Well Name: E SMITH RANCH	Well Location: T20S / R33E / SEC 12 / NWNW /	County or Parish/State: LEA / NM
Well Number: 01	Type of Well: CONVENTIONAL GAS WELL	Allottee or Tribe Name:
Lease Number: NMNM40406	Unit or CA Name:	Unit or CA Number:
US Well Number: 3002527709	Well Status: Producing Oil Well	Operator: COG OPERATING LLC

Notice of Intent

Type of Action: Plug and Abandonment

Plug Abandonment NOI Proposed

COG Operating LLC		PROPOSED	
Author:	Abby @ BCM	Well No.	#1
Well Name	East Smith Ranch Fed	API #:	30-025-27709
Field/Pool	Teas; Bone Spring	Location:	Sec 12. T20S, R33E
County	Lea		990 FNL & 990 FWL
State	New Mexico	GL:	3590
Spud Date	2/27/1982

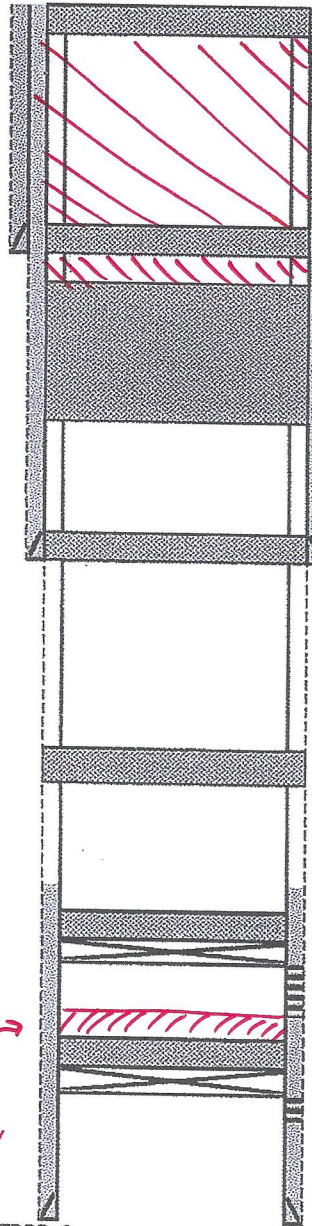
→ T/Salt 1750'±
 Cap @ 3673'
 Base salt @ 3197'

870 sx 3723' to surface, verify @ surface

90 5225'

50

Wolfcamp
& Morrow

See procedure

1. Tag 5 1/2" CIBP @ 13,120' w/ 35' cmt cap on top.
2. Set 5 1/2" CIBP @ 9343'. Circ hole w/ MLF. Pressure test csg. Spot 25 sx cmt @ 9343-9143'.
3. Perf & Sqz 50 sx cmt @ 8405-8205'. (Bone Springs)
4. Perf & Sqz 50 sx cmt @ ~~5055-4855'~~. WOC & Tag (8 5/8" Shoe) 90 sx (5225' to 4855')
5. Perf & Sqz ~~380~~ sx cmt @ ~~3470-1600'~~. WOC & Tag **POTASH R-111-P** 870 sx
6. Perf & Sqz 50 sx cmt @ ~~1445-1245'~~. WOC & Tag (Rustler, 13 3/8" Shoe) (3723' to surface)
7. Perf & Sqz 50 sx cmt @ ~~200'~~ to surface.
8. Cut off well head, verify cmt @ surface, weld on Dry Hole Marker.

→ Spot from 12984' to 12754' (Morrow) 30 sx
 Spot from 11300' to 11087' (Wolfcamp) 30 sx

Plug Type	Top	Bottom	Length	Tag	Sacks	Notes
Surface Plug	0.00	200.00	200.00	Tag/Verify		
Shoe Plug	1345.00	1445.00	100.00	Tag/Verify		
Top of Salt @ 1750	1682.50	1800.00	117.50	Tag/Verify		
Base of Salt @ 3197	3115.03	3247.00	131.97	Tag/Verify		
Yates @ 3420	3335.80	3470.00	134.20	If solid		
Capitan Reef @ 3673	3586.27	3723.00	136.73	If solid base no need to Tag (CIBP present and/or Mechanic al Integrity Test), If Perf & Sqz then Tag, Leak Test all CIBP if no Open Perforatio	870.00	Perf and Squeeze from 3723' to Surface'. WOC and Tag (In/Out) <i>Verify @ surface.</i>
Shoe Plug	4953.00	5225.00	272	Tag/Verify	90	Perf and Squeeze from 5225' to 4855'. WOC and Tag. (In/Out)
Bonesprings @ 8355	8221.45	8405.00	183.55	If solid base no need to Tag (CIBP present and/or Mechanic al Integrity Test), If Perf & Sqz then Tag, Leak Test all CIBP if no Open Perforatio	50.00	Perf and Squeeze from 8405' to 8205'. WOC and Tag. (In/Out)
